Output CLK from SCL2 is skipped though CLK is input to SCL1 correctly. This behavior is confirmed when the load current at DC/DC converter on the same board is heavy, so the VCC or GND line may be noisy.

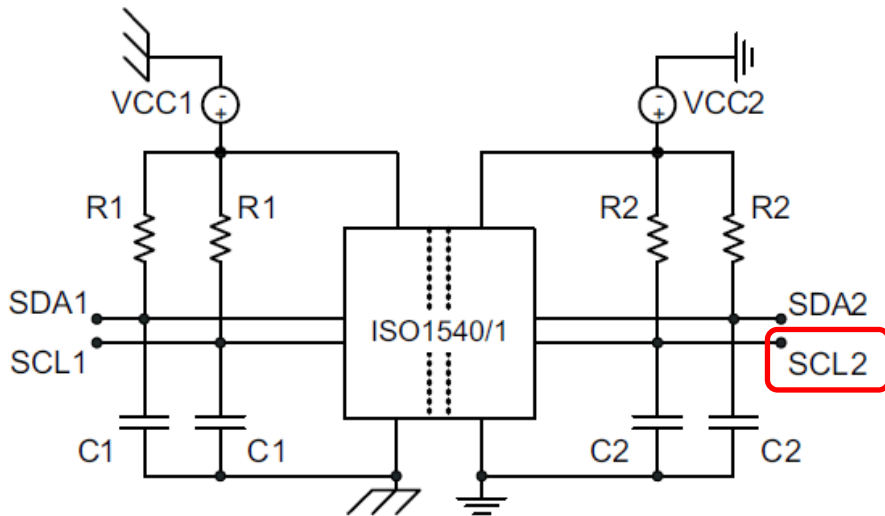
Changed referred GND

Is it possible that the noise on VCC or GND will be the cause of such pulse skip?
